**BEFORE THE INDEPENDENT HEARING PANEL APPOINTED BY THE
QUEENSTOWN LAKES DISTRICT COUNCIL**

UNDER the Resource Management Act 1991 (RMA)
IN THE MATTER of the Te Pūtahi Ladies Mile Plan Variation in accordance
with section 80B and 80C, and Part 5 of Schedule 1 of the
Resource Management Act 1991.

**JOINT STATEMENT OF LANDSCAPE EXPERTS IN RELATION TO SLOPE
HILL OUTSTANDING NATURAL FEATURE**

DATED 18 OCTOBER 2023

Figure 1 - Image showing the potential location of water tanks within the ONF (provided by Saddleback)

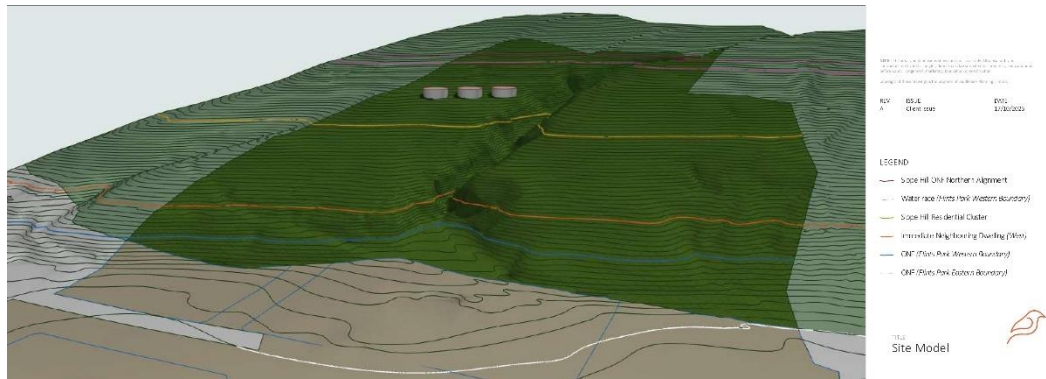
<p>Is the Slope Hill ONF boundary correct?</p>	<p>[e] The experts agree that the water tanks may be able to be absorbed on the site assuming:</p> <ul style="list-style-type: none"> • They are located to optimise the integrating influence of the more complex localised landscape patterning associated with the vegetated gully on the Glenpanel site. • They are positioned so that they can be accessed via the existing farm track network (thus avoiding the need to cut a new track across the south side of the roche moutonnée). 	<p>7) Messrs Milne and Compton Moen consider that the existing Slope Hill PA ONF boundary is generally appropriate. It is their view that the UGB (and limited urban development) can overlap the Slope Hill PA ONF in this location, without compromising its key landscape values. However, if this is not the case, they consider that a finer grain assessment of the ONF boundary may determine a more appropriate boundary. Such an assessment would require the input of other experts (geologists, ecologists etc).</p> <p>8) Relying on her field work, review of Geology mapping, the Topic 2 Decisions and Dr Marion Read reports for the PDP Stage 1, and her landscape evaluation as part of the PA</p>

Issue	Agreed Position	Disagreements or reservations, with reasons
	<ul style="list-style-type: none"> • The tanks are positioned to be at least partially buried (where practicable) and finished in a visually recessive colour. • The tanks are mitigated via: localised naturalised landform modification that is designed to marry in the with surrounding slope profiles; and/or indigenous restoration planting that is configured to integrate with the existing gully planting patterning (and thus form a cohesive and coordinated landscape element that reinforces the underlying topographical patterning). <p>[f] The experts acknowledge that the ‘success’ of such measures in ensuring the water tanks sit comfortably into the RMA s6(b) ONF landscape setting would however need to be tested via a detailed landscape assessment.</p> <p>[g] In their opinion, it is not uncommon that infrastructure of this nature needs to be located within ONF/Ls in the district. This is due to the following:</p> <ul style="list-style-type: none"> • the fact that approximately 97% of the district is ONF/L; • such infrastructure tends to have quite specific operational and functional needs; and • there is often ‘nowhere else to go’ for such infrastructure. <p>[h] The experts agree that from a landscape perspective, they do not consider that water tanks in their own right, read as urban development.</p>	<p>Schedules and Wakatipu Basin Land Use Planning Study, Ms Gilbert agrees with the Decisions Version of the Slope Hill PA ONF mapping along the south side of the roche moutonnée.</p>

Issue	Agreed Position	Disagreements or reservations, with reasons
<p>What are the effects of water tanks at that location?</p>		<p>9) Messrs Milne and Compton-Moen consider that the potential landscape effects are on the values of the Slope Hill PA ONF. These include the following:</p> <ul style="list-style-type: none"> i. A 'very low' level loss of openness. ii. A 'very low' level loss of naturalness. However, a high perception of naturalness (that arises from the dominance of natural landscape elements and patterns at Slope Hill) will remain. iii. The built form of the water tanks remains subservient to the natural form of Slope Hill. <p>10) Potential effects on visual amenity as experienced from the highway and the wider receiving environment. These include:</p> <ul style="list-style-type: none"> i. the water tanks will be either not seen or barely noticeable in views of Slope Hill from a distance (for example the Remarkables Ski Field Road, SH6 adjacent to Lake Hayes) due to distance, topography, vegetation, and the coverall context of the viewing environment. They will have no impact on the broader ONL mountain context in these views. ii. The water tanks will be seen in views from immediately opposite the Glenpanel Site (eg. Howards Drive). In these views a sense of openness will be diminished, albeit the tanks will be seen in association with the adjacent gully planting. These views will also change markedly with the TPLM Variation, and the tanks will be viewed in the context of the TPLM Variation and
